PROJECT NAME: Rossland Arena

PROJECT NO.: 17294.002

ADDENDUM NO.: E-01 R1

2. REFERENCE: DRAWING E-1

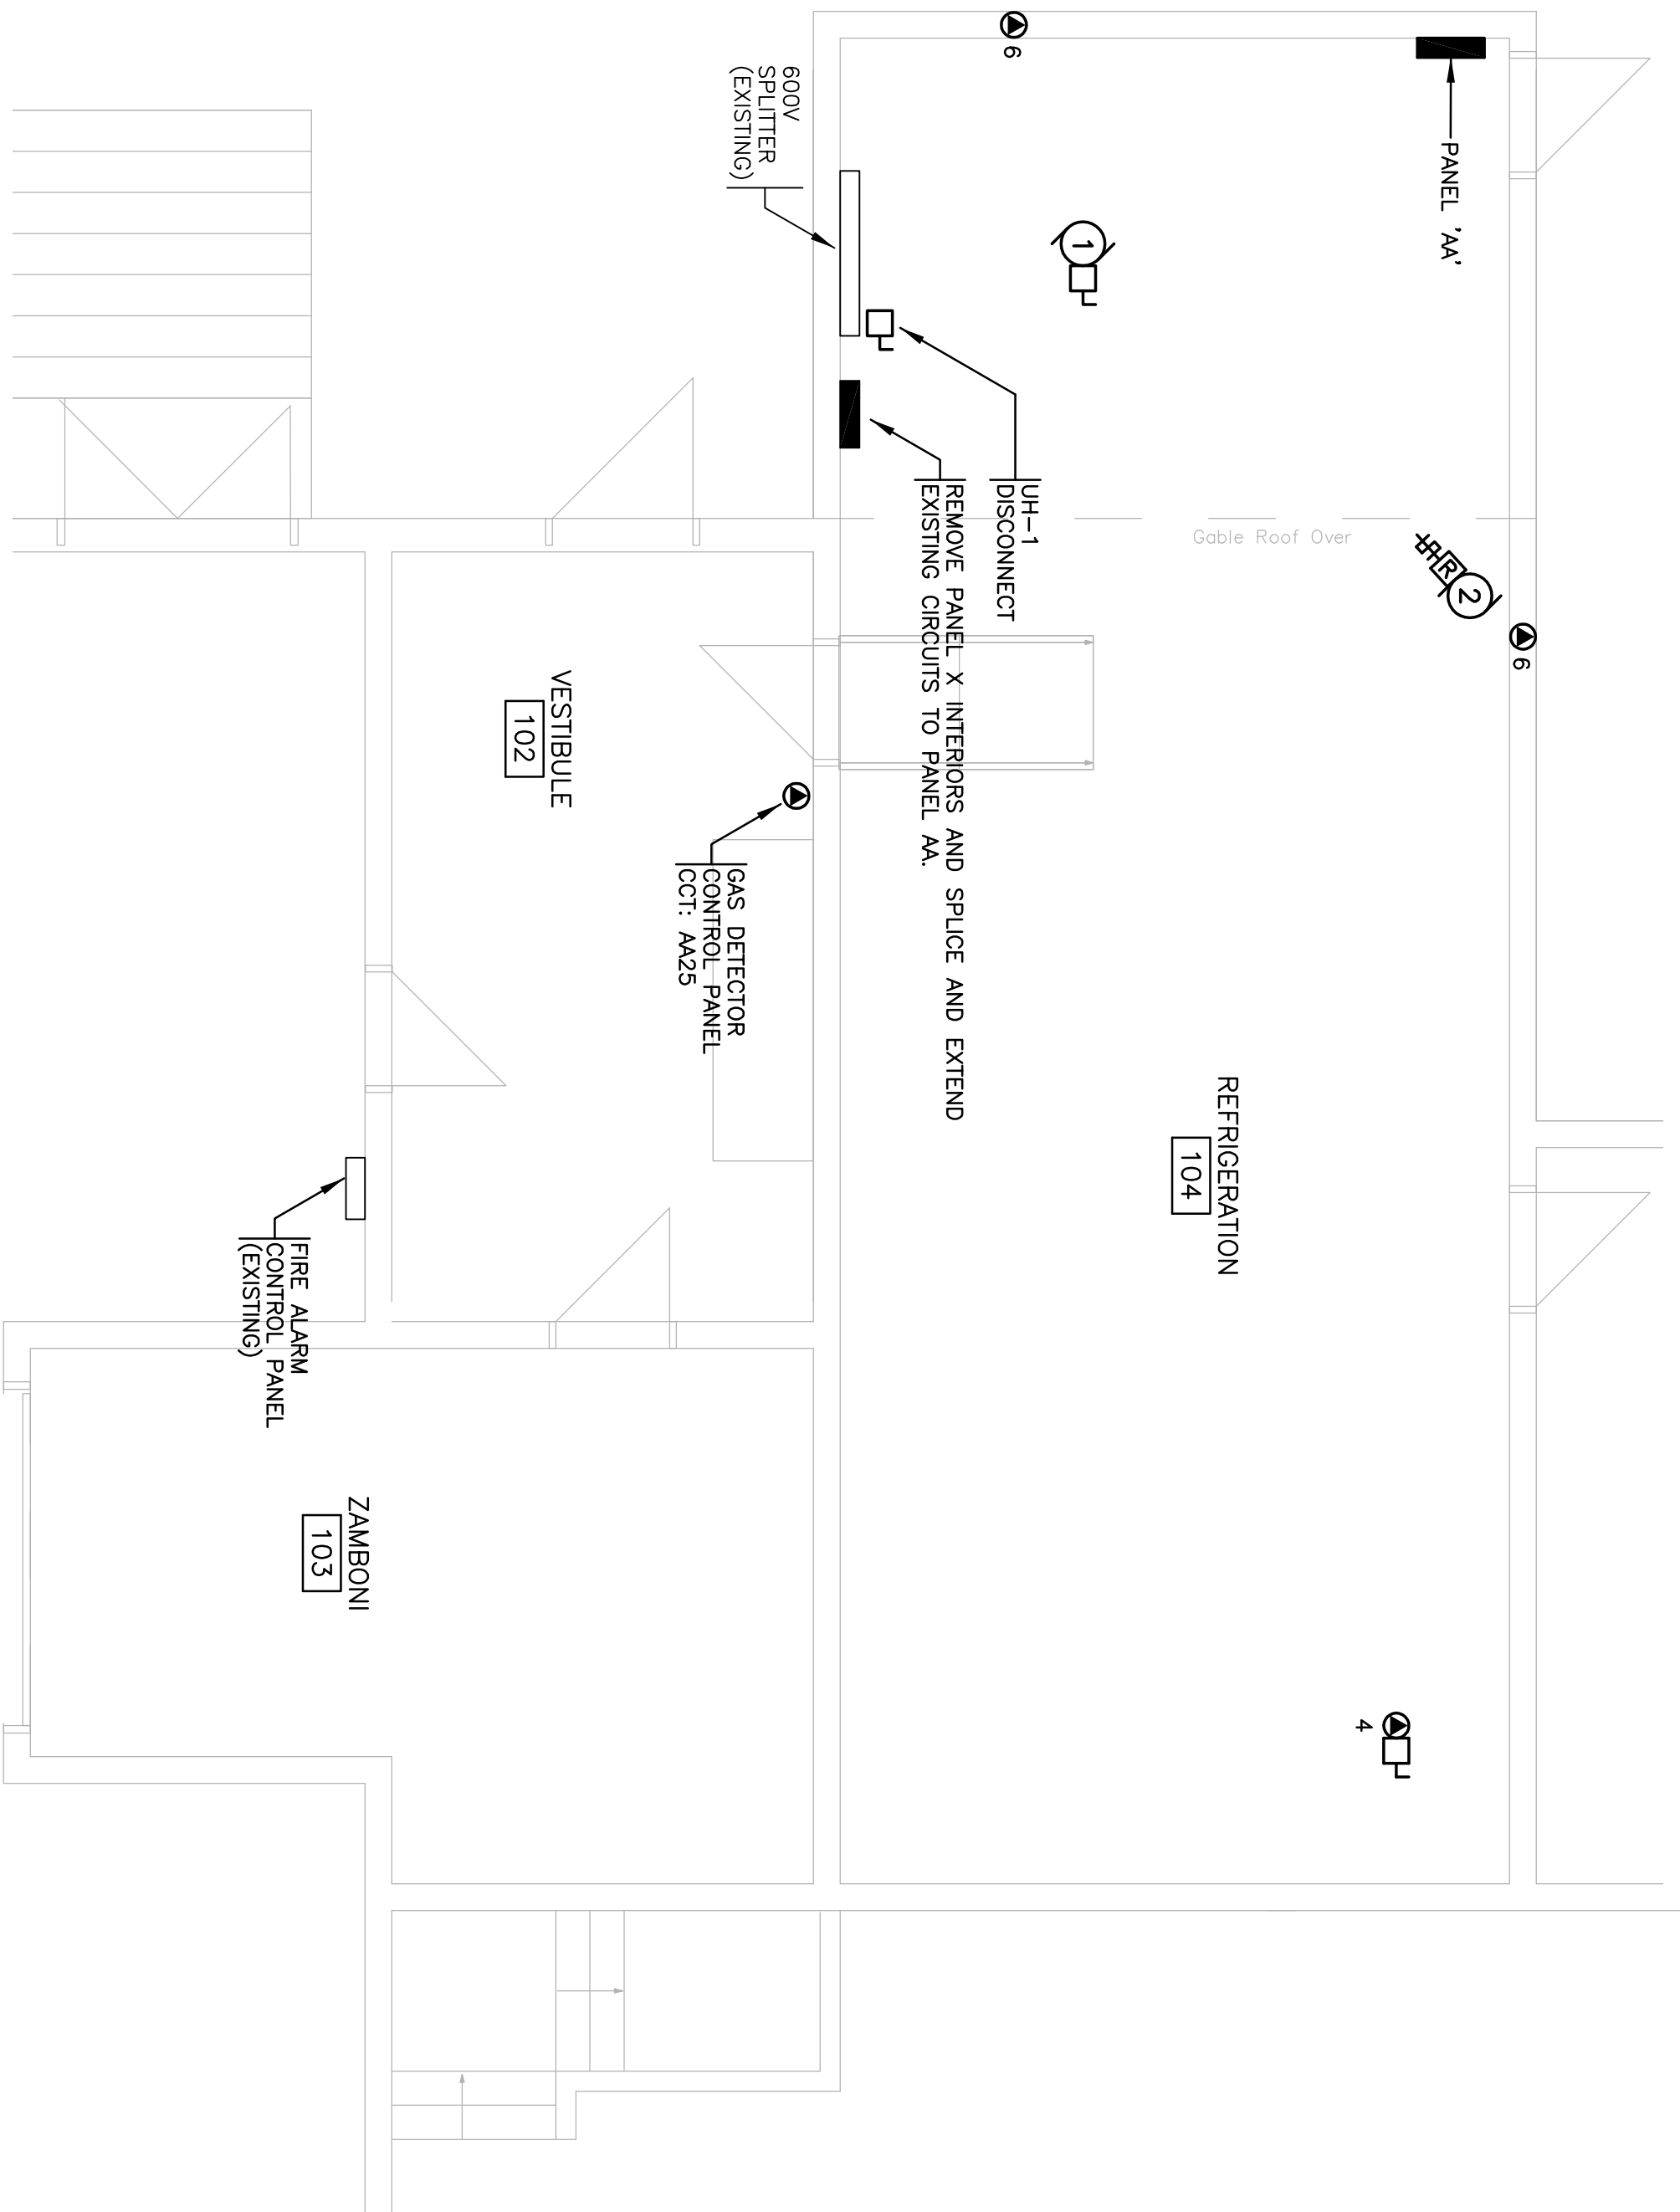
1. Refer to the attached for location of panel AA. Extend existing feeder from panel X to panel AA. Splice and extend existing panel X branch circuit wiring and extend to panel AA. Provide a painted steel cover for panel X.
